South Coast Air Quality Management District

January 15, 2026

**Draft Environmental Impact Report (EIR) for the Proposed
The Cubes at Placentia Industrial Project (Proposed Project)**
(SCH No.: 2023120020)

Figure 1: Snapshot from Appendix B

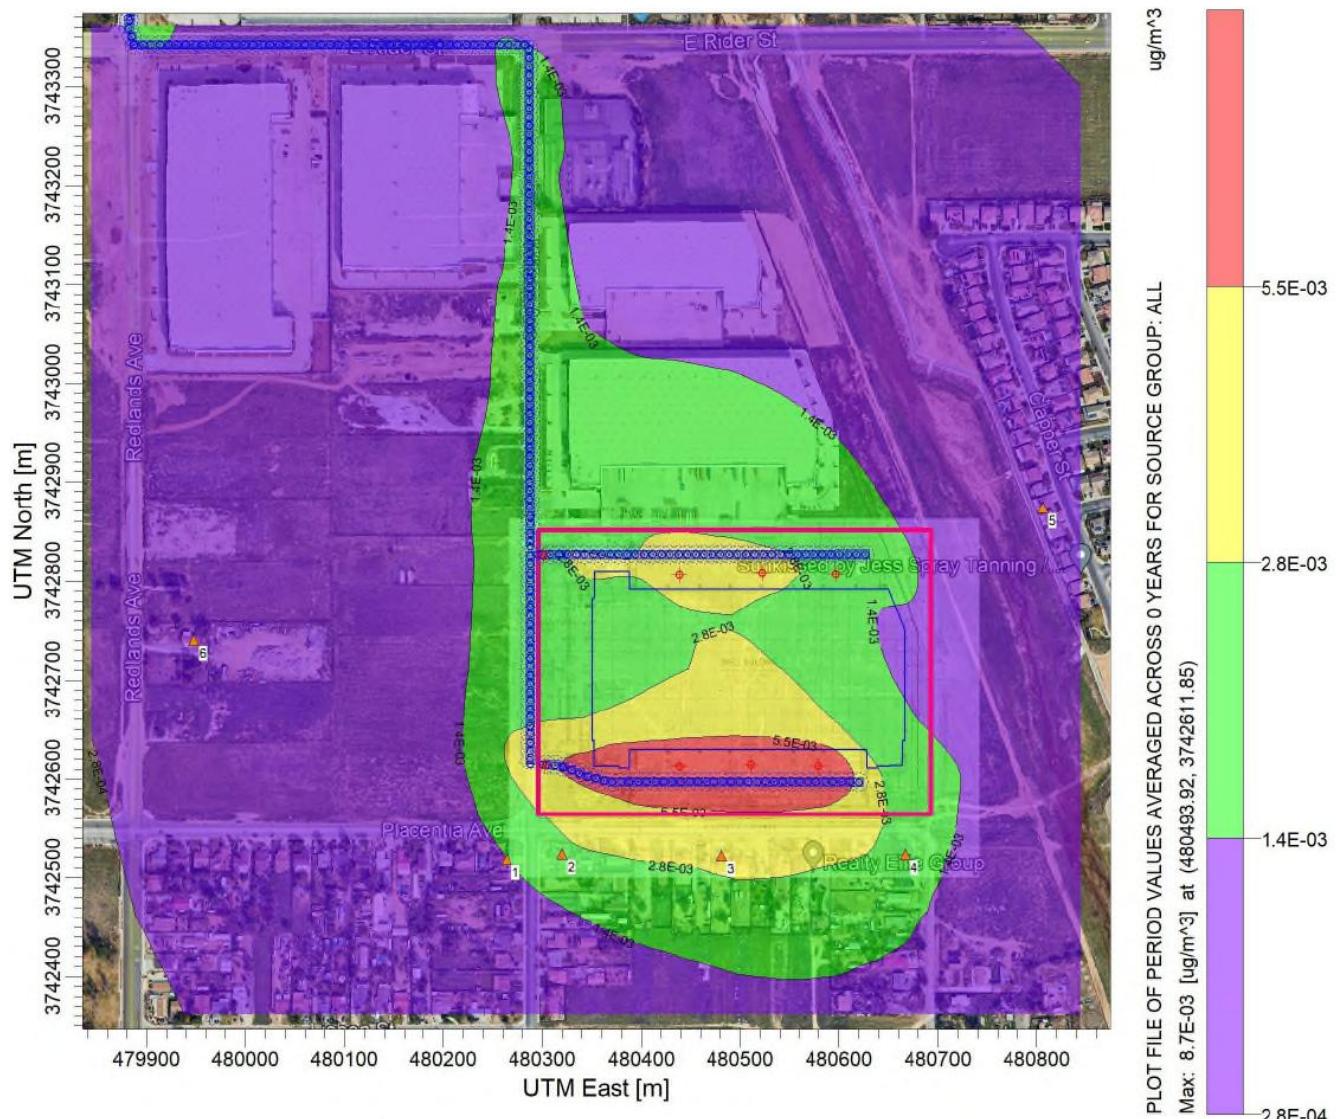
Section 4.2 (Air Quality) of the Draft EIR presents the Health Risk Assessment (HRA) for the Proposed Project and reports a maximum incremental cancer risk of 2.32 in one million at Receptor Location 3 (coordinates 480481.51, 3742521.83).¹² Figure 1 (from Appendix B) provides a snapshot of the AERMOD modeling results and identifies the receptor locations used in the analysis. Based on Figure 1, the maximum modeled concentration is 5.5×10^{-3} micrograms per cubic meter ($\mu\text{g}/\text{m}^3$).¹³ However, a review of the AERMOD modeling files provided by the Lead Agency indicates discrepancies between the concentrations reported in Appendix B and those generated directly from the modeling output. Specifically, the same AERMOD modeling file yields a maximum modeled concentration of approximately $0.201 \mu\text{g}/\text{m}^3$,¹⁴ which is substantially higher than the maximum concentration reported in Appendix B.

In addition, Appendix B reports a concentration of $0.00312 \mu\text{g}/\text{m}^3$ at Receptor Location 3,¹⁵ corresponding to the stated maximum cancer risk of 2.32 in one million. Further review of the provided AERMOD output files indicates that the modeled concentration at Receptor Location 3 is approximately $0.00825 \mu\text{g}/\text{m}^3$,¹⁶ which would correspond to an estimated cancer risk of approximately 7 in one million, assuming the same risk calculation methodology and unit risk factors used in the HRA.

These inconsistencies between the concentrations and cancer risk values reported in Appendix B and those derived directly from the AERMOD modeling files provided by the Lead Agency raise concerns regarding the accuracy and transparency of the HRA presented in the Draft EIR. These discrepancies affect the public's ability to evaluate the magnitude of health risks and undermine confidence in the Draft EIR's conclusion that impacts are less than significant. Under CEQA, an

Accordingly, the Lead Agency is recommended to re-examine the HRA, verify the modeled concentration outputs, and revise the cancer risk calculations as necessary to ensure consistency between the modeling files, results tables, figures, and narrative discussion. The corrected modeling results and corresponding health risk estimates should be clearly documented and presented in the Final EIR. Even if the revised cancer risk values remain below applicable significance thresholds and are ultimately determined to be less than significant, the Final EIR should disclose the correct concentrations and associated cancer risk estimates to accurately characterize the potential health risk impacts of the Proposed Project on nearby sensitive receptors, consistent with CEQA requirements for full disclosure and informed decision-making.
